**PLANNING AND ZONING COMMISSION ACTION ITEM  
STAFF SUMMARY  
SEPTEMBER 12, 2022 PLANNING AND ZONING COMMISSION SPECIAL MEETING**

**AGENDA ITEM NUMBER:** 8

**A RESOLUTION RECOMMENDING THE APPROVAL OF AN  
APPLICATION FOR A CLASS S-2 SUBDIVISION TO BE KNOWN AS A  
RESUBDIVISION OF LOT 17, BLOCK B, NEW TOWN OF DILLON.**

**Figure 2. Lot Width Determination**

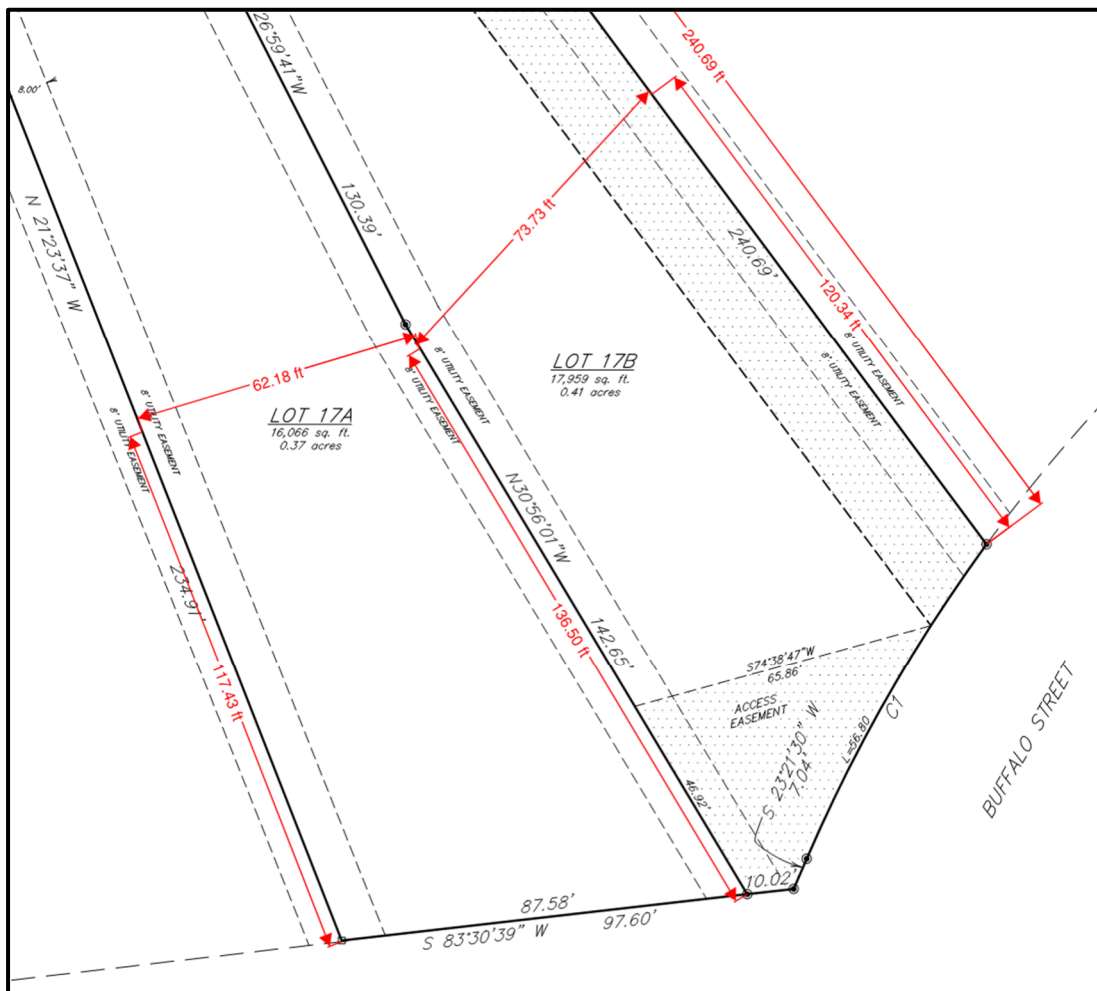
Lot Width = 60 feet and 65 feet for corner lots  
 Lot 17A: 62.2 feet and Lot 17B: 73.7 feet (Corner Lot) – meets Code  
 See **Figure 2**. For Lot Width Determination

**Exhibit 'A'**  
**Exhibit Map and Topography of Lot 17, Block B**  
**New Town of Dillon subdivision**

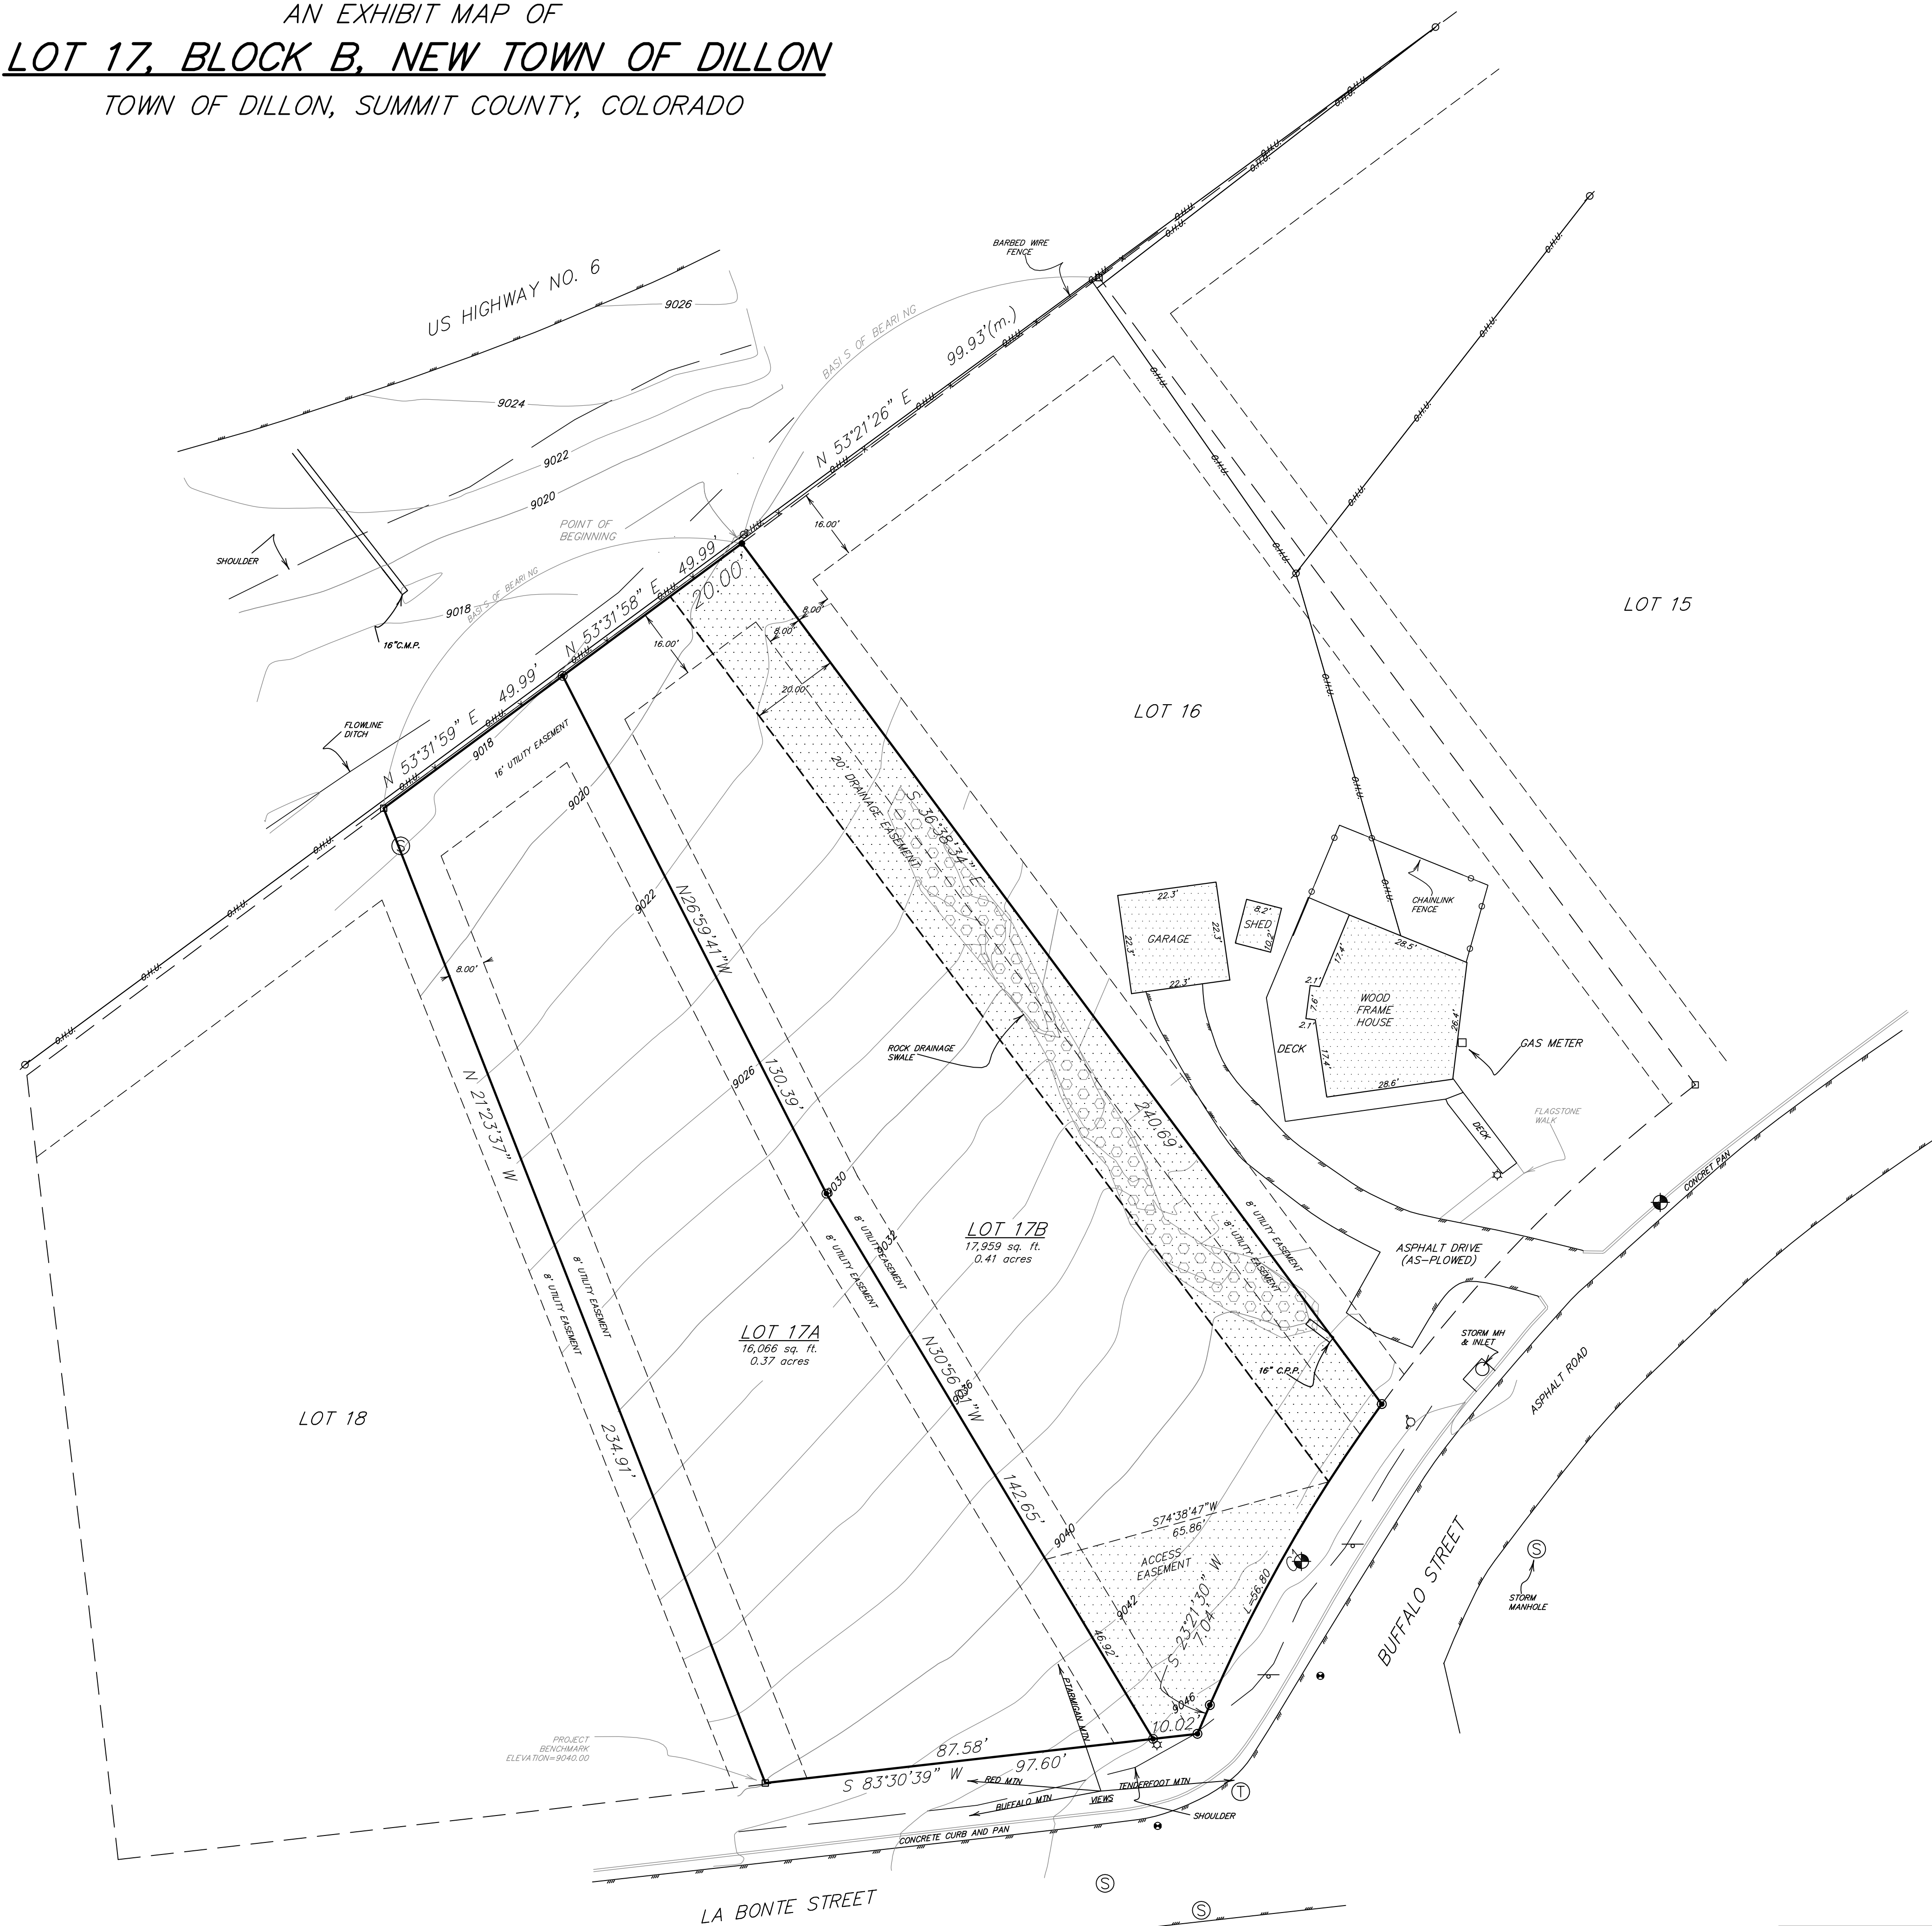
- A. Prior to the publication of materials for the Town Council public hearing and review of the Application, the Applicant shall correct the Owner's Certificate and Dedication on the Plat to reflect the names of both property owners.
